NASA Electronic Parts and Packaging (NEPP) Program 2018 Electronics Technology Workshop

NEPP Program Task 18-294 Government Working Group Update

1. Radiography Inspection Criteria

• Example 1: Excessive Voiding Underneath Lid

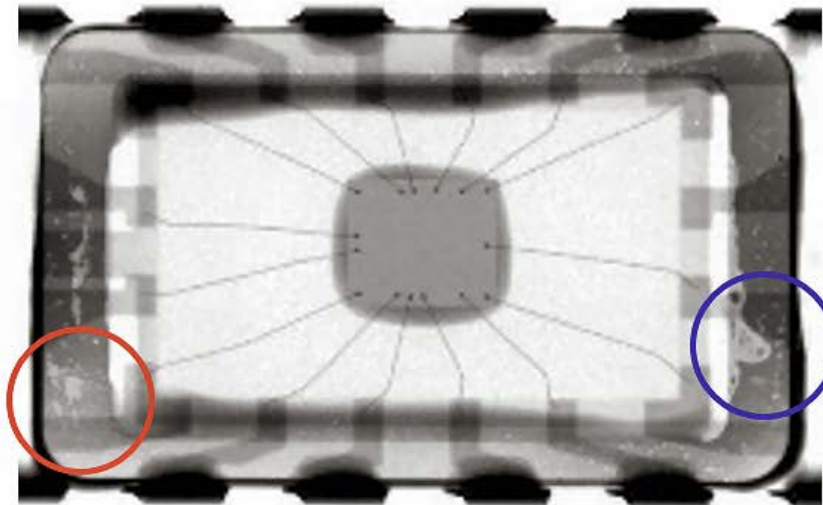
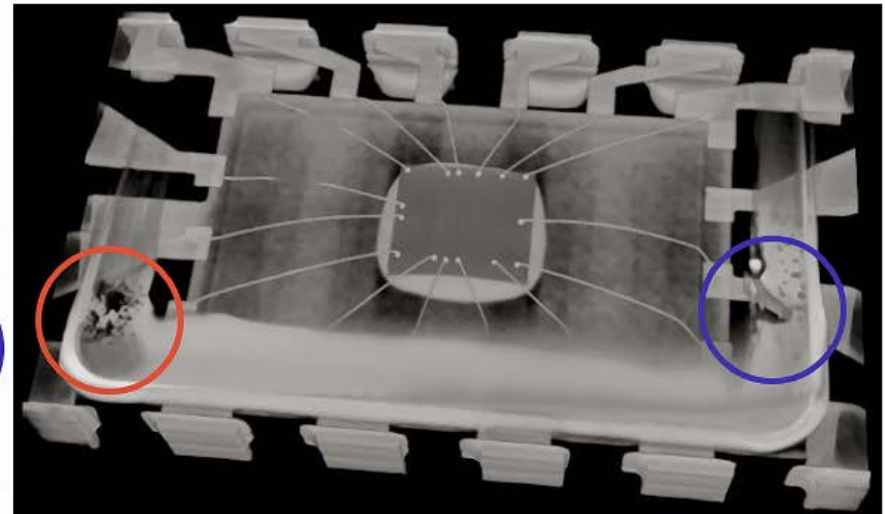
- Voids may reduce sealing width underneath the lid by more than 75% and also contact the fillet.
 - Microcrack(s), not distinguished in x-ray, may compromise seal integrity as they can propagate to a void area.
- The current lid seal requirements would fail this device, yet pass if the fillet is included in the intended seal width.

This part was a randomly selected sample and had this void issue. Because this part was randomly selected, it is highly probable that there are other parts with similar issues.

• Example 1: Excessive Voiding Underneath Lid (continued)

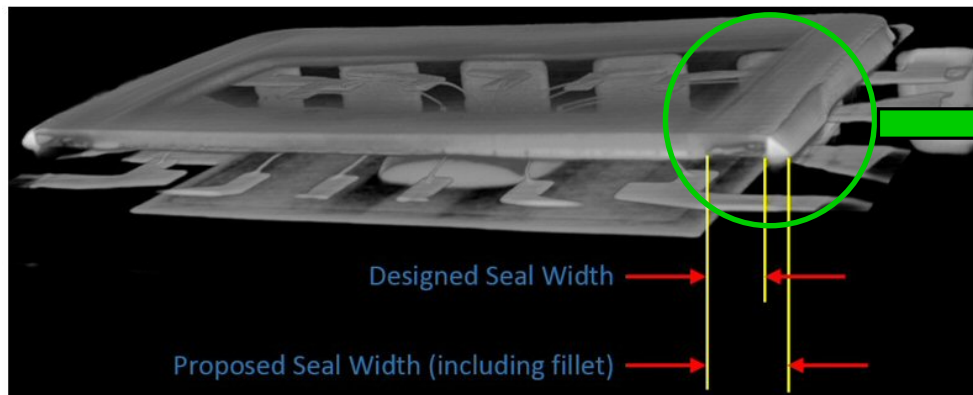
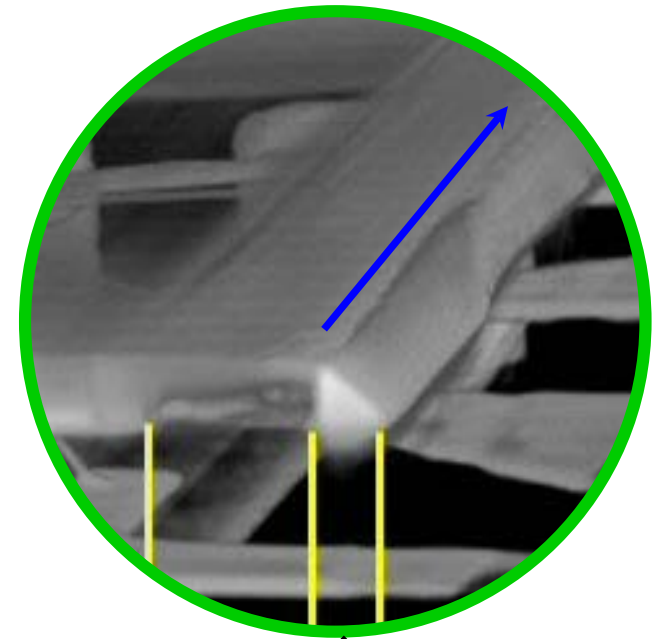
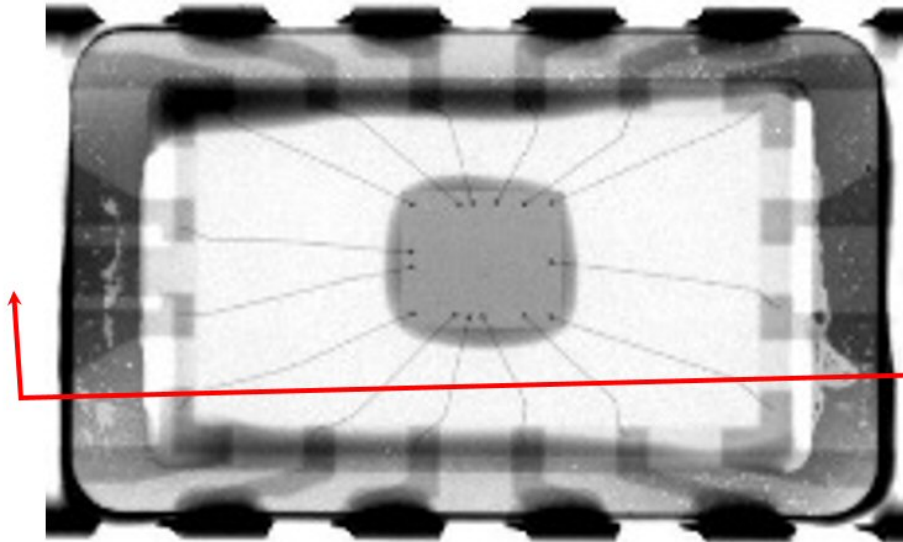
- The current lid seal requirements would fail this device, yet it would pass if the fillet is included in the intended seal width.

Darkened areas in the designed seal width are voids and the fillet width tapers (blue arrow).

• Example 2: Excessive Voiding Underneath Lid

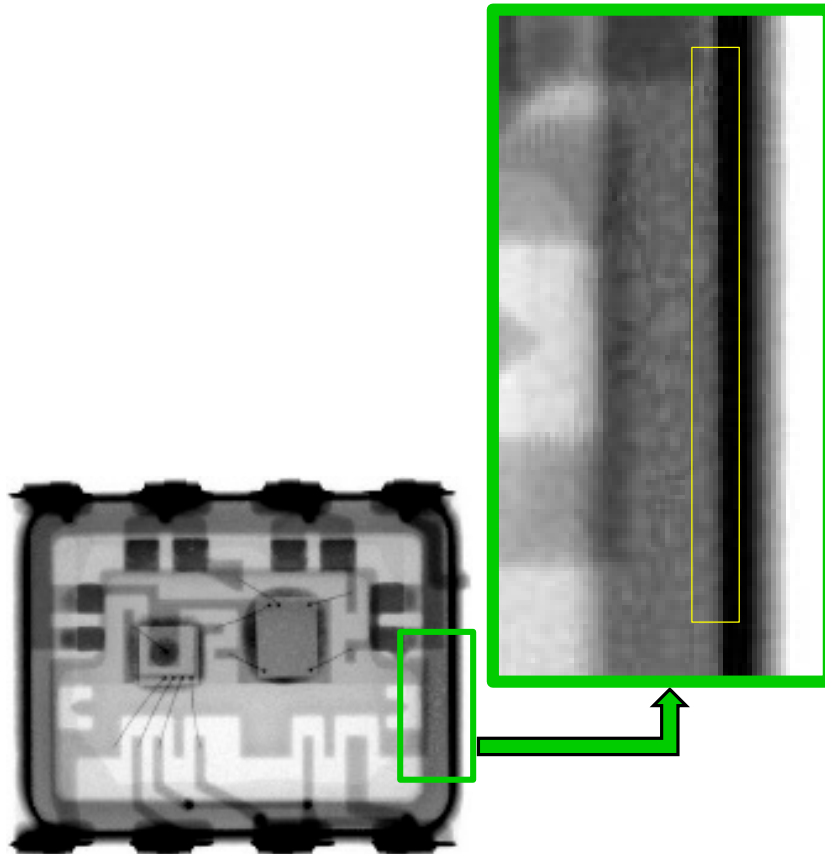
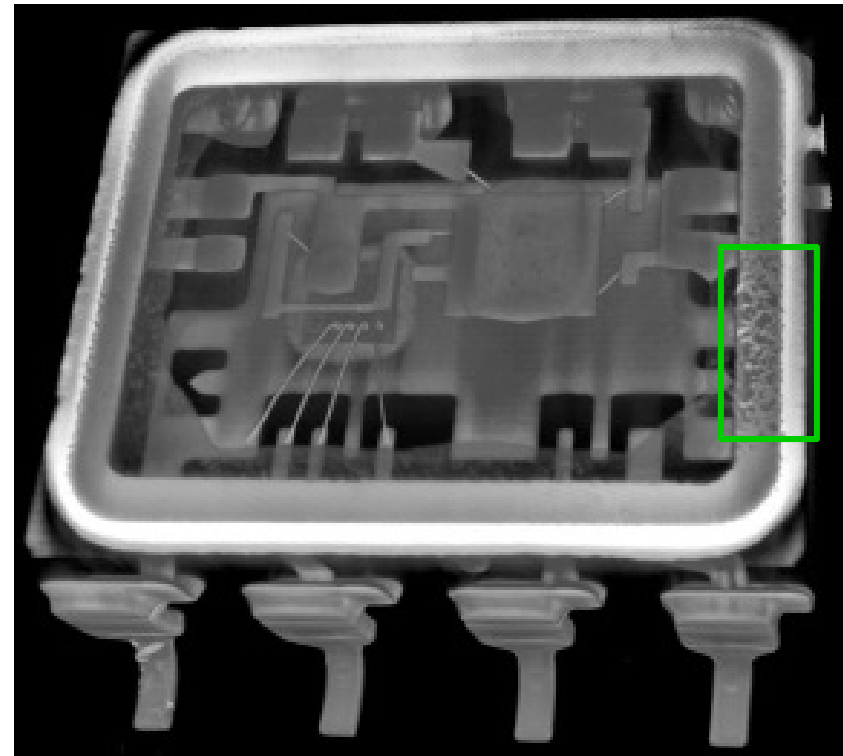
- Voids reduce sealing width underneath the lid by more than 75% and pinholes exist in fillet area next to the lid. Note that the pinholes are not clearly detected in the 2D x-ray image (yellow box) due to the thick, x-ray dense solder of the fillet.

• Example 2: Excessive Voiding Underneath Lid (continued)

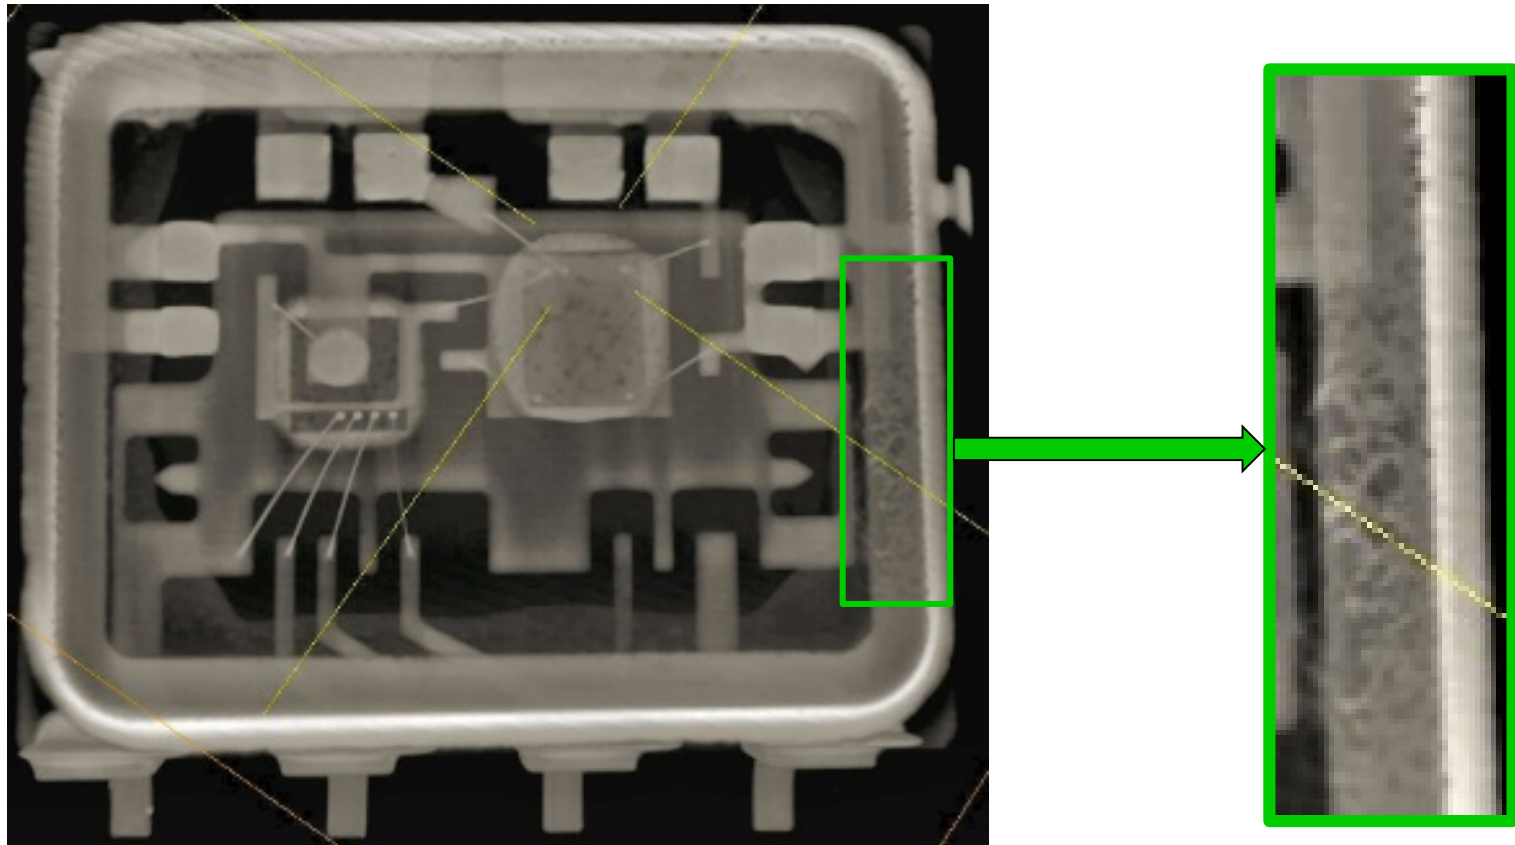
- Another 3D-CT image of the device shown on Slide 9. This part would fail the current criteria, but would pass if the fillet was included in the design width. Note the pinholes in the fillet next to the edge of the lid, which provides a potential leak path.

FIGURE 2012-5. Lid seal voids and rejection criterion.

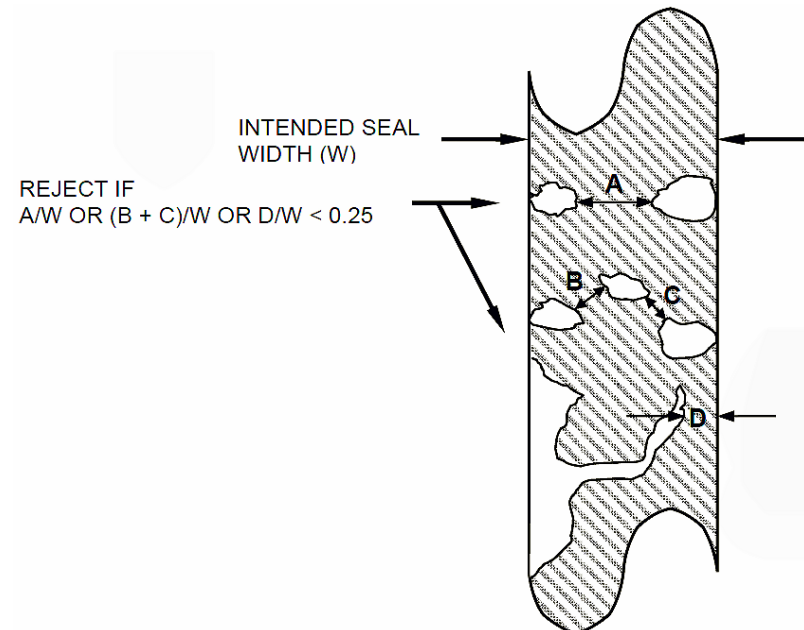
- **JEDEC Task Group proposal to change MIL-STD-883 TM2012 X-ray lid seal failure criterion.**

- Would remove “B + C” requirement and replace with seal length calculation along perpendicular line drawn from edge of package to cavity
- Would allow fillets to be part of intended seal width
- GWG does not support this change

X-ray Image of Voids

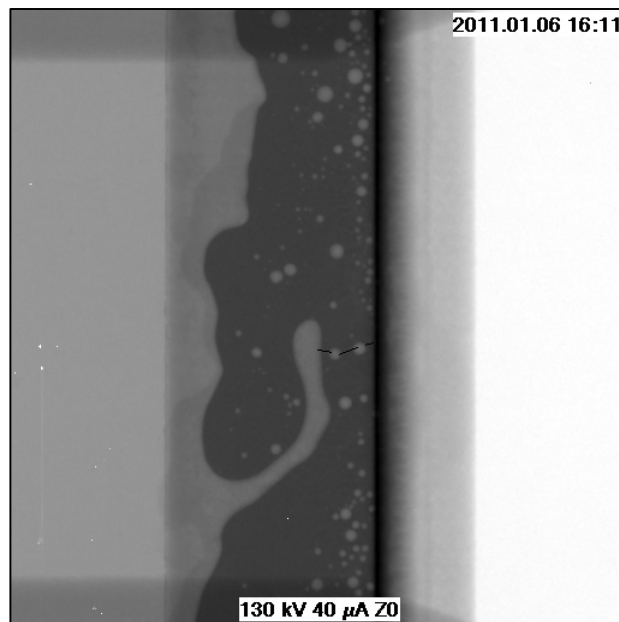
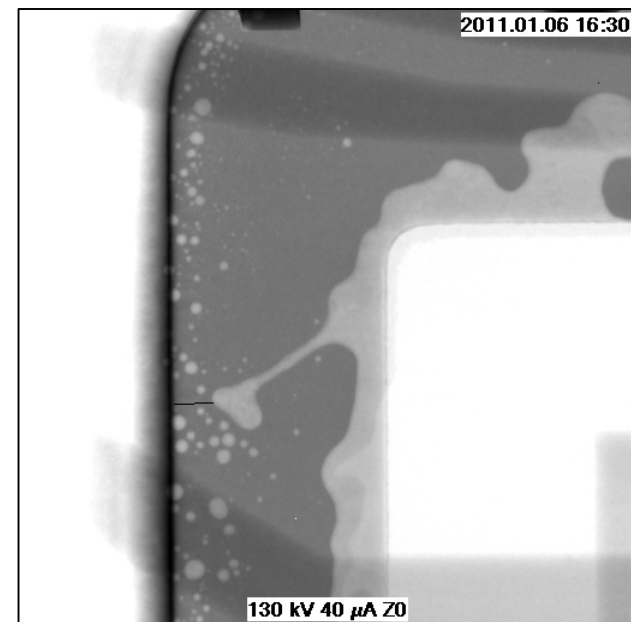
- JEDEC Task Group proposal to change MIL-STD-883 TM2012 X-ray lid seal failure criterion (cont.)
 - These microcircuits would pass the new criteria
